Errata 3 to TS 102 796 V1.2.1

2016-06-07

This document contains the currently identified and resolved errata to ETSI TS 102 796 v1.2.1. It is a living document which will be updated based on experience of implementing receivers, services and tests. Versions of this document will periodically be made publicly available via the www.hbbtv.org web site.

Replace Figure 13 with:

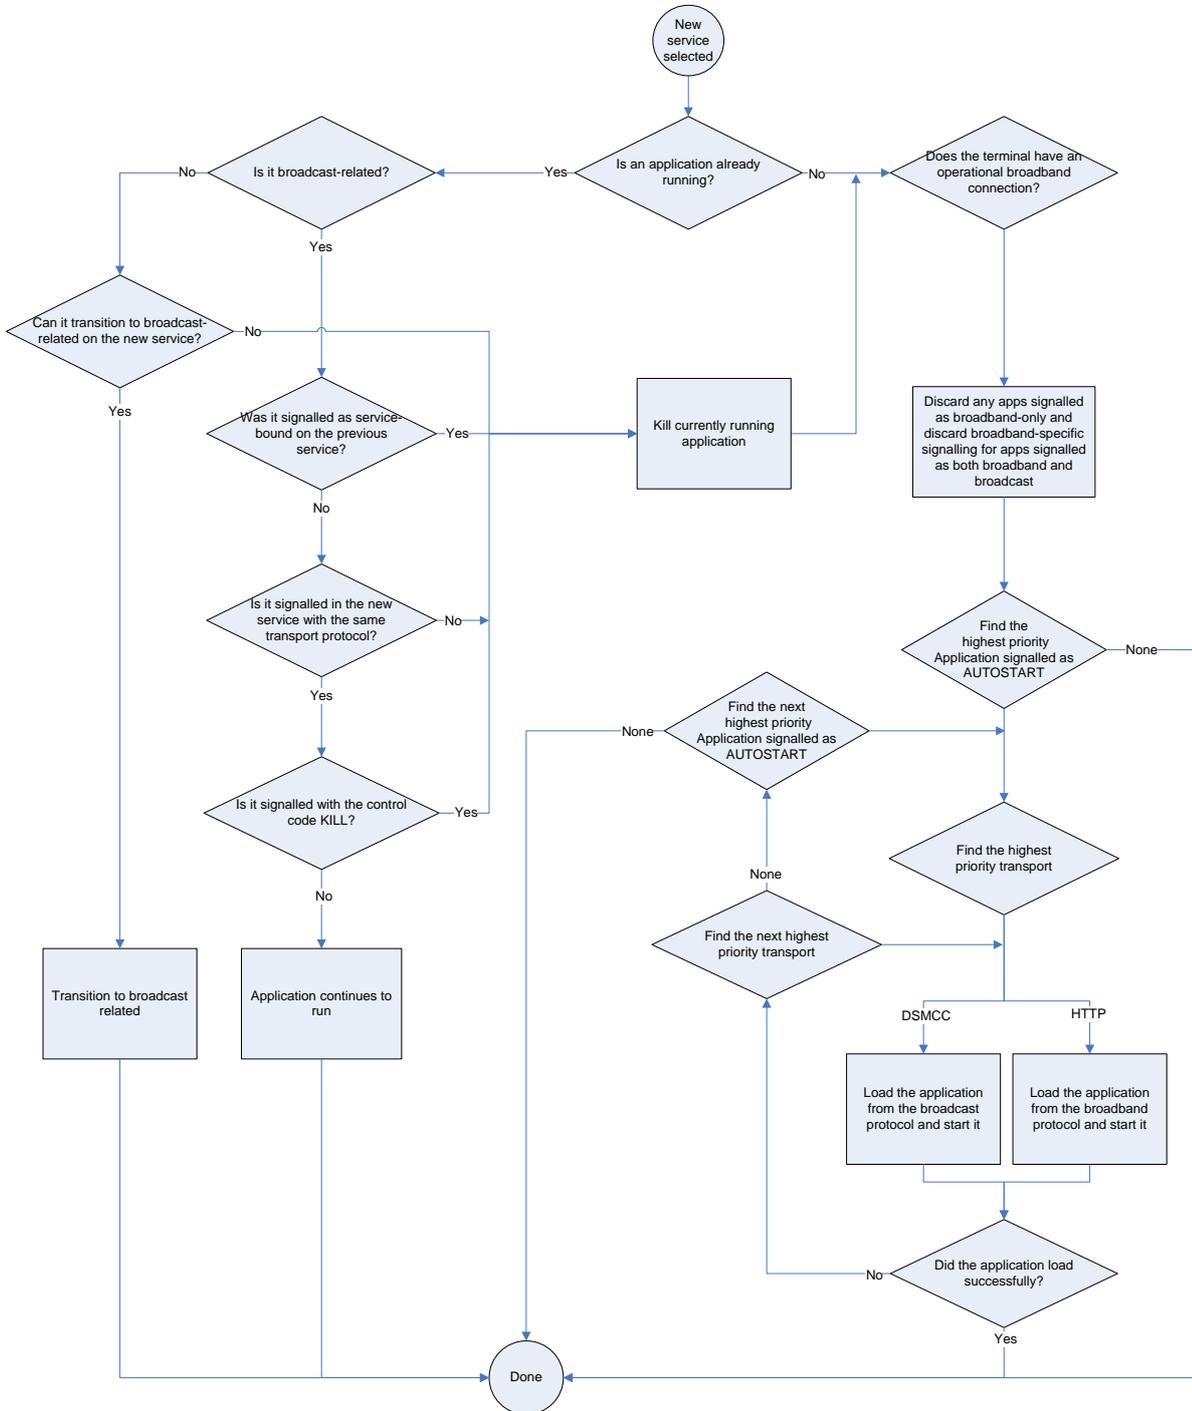
4.3.2 Modification to application lifecycle on channel selection

Replace Figure 14 with:

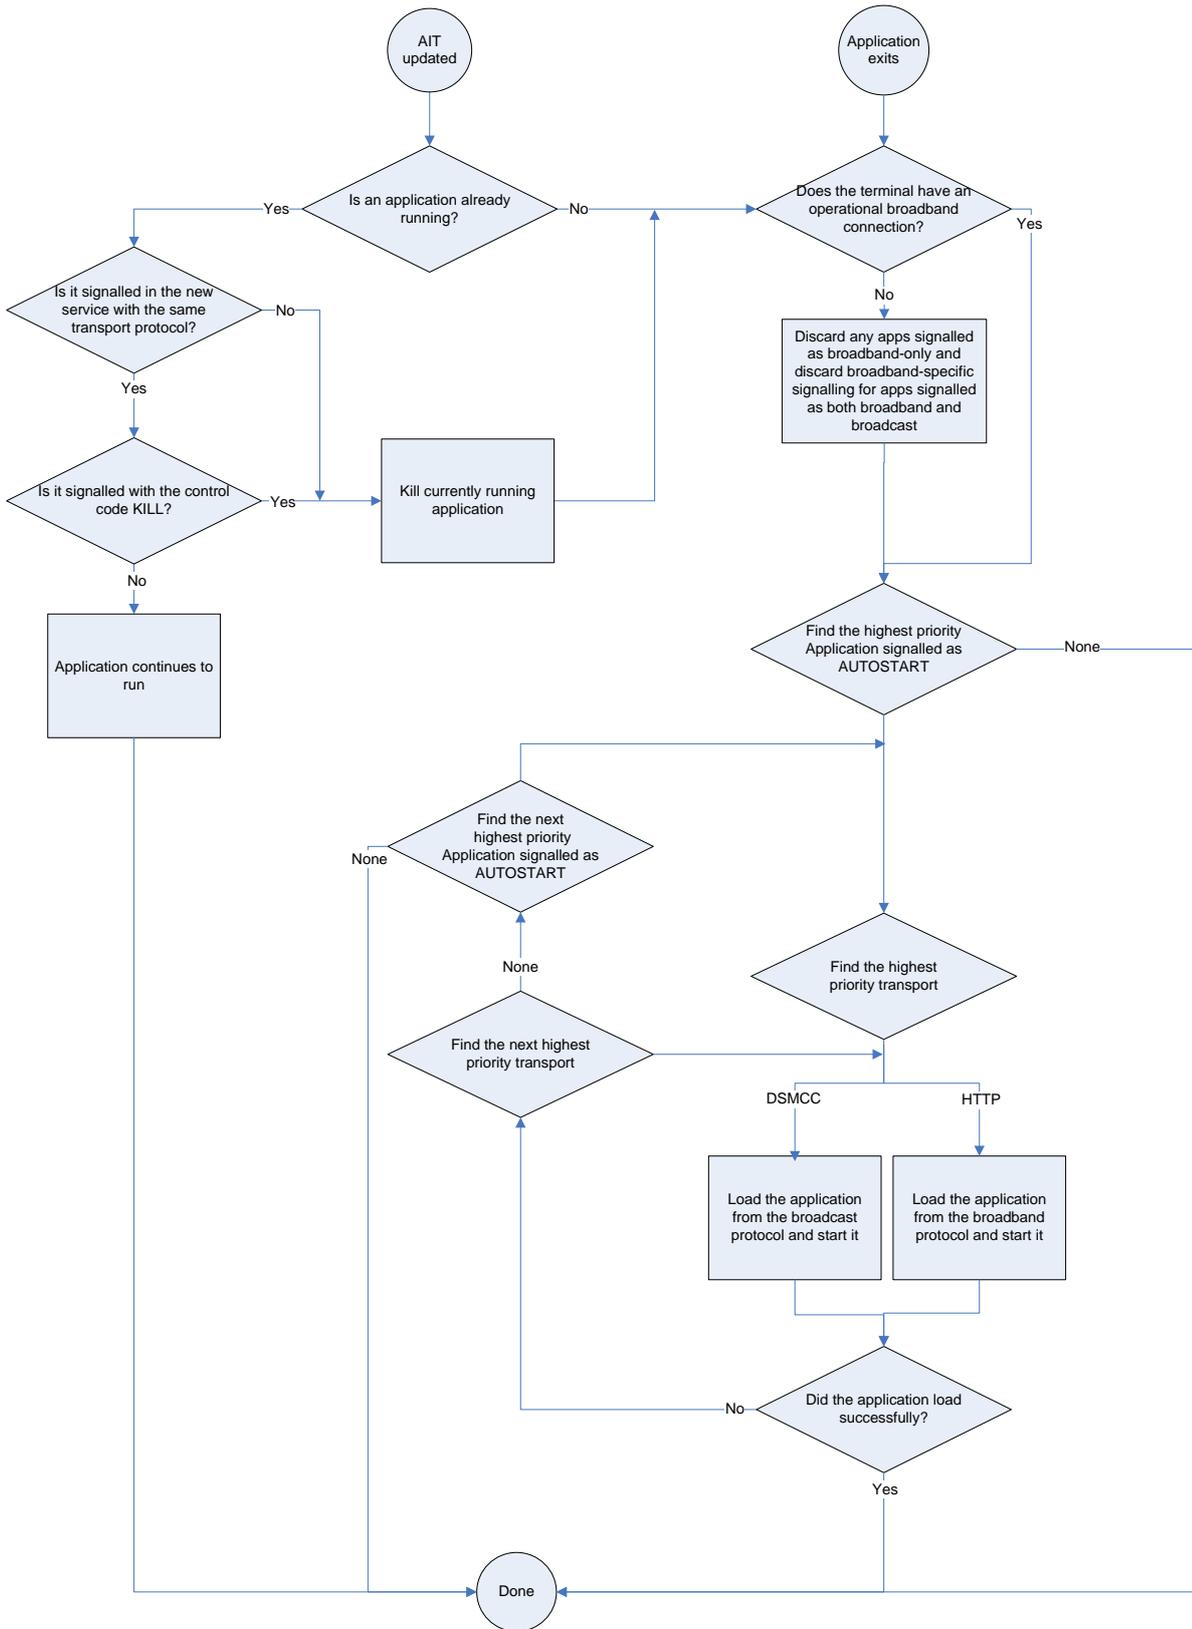
4.3.3 Remove reference to external application authorisation descriptor

Figure 16: PVR States for `recordNow` using `video/broadcast` (normative)

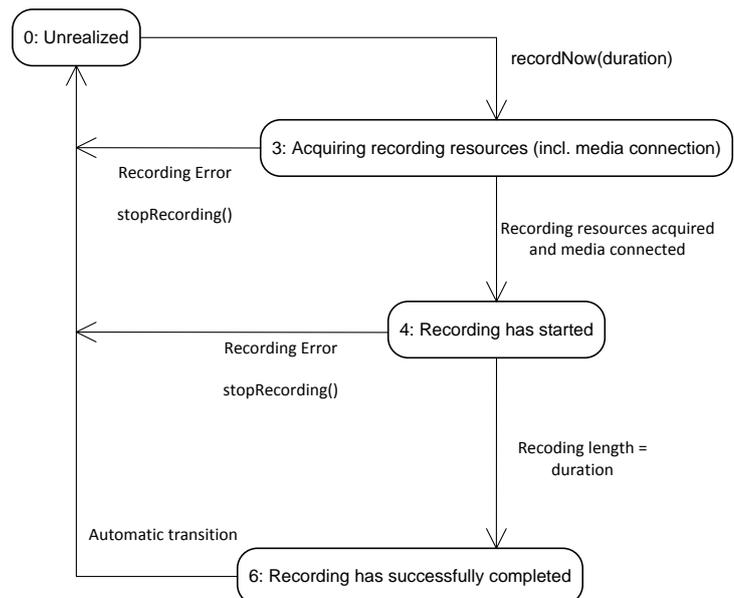
The recording functionality is subject to the state transitions represented in the state diagram in Figure XX.

Note that when the user switches to another channel whilst the current channel is being recorded using `recordNow` or the `video/broadcast` object gets destroyed, the conflict resolution and the release of resources is implementation dependent. The terminal may report a recording error using a `RecordingEvent` with value 0 (“Unrealized”) for argument state and with value 2 (“Tuner conflict”) for argument error in that case.
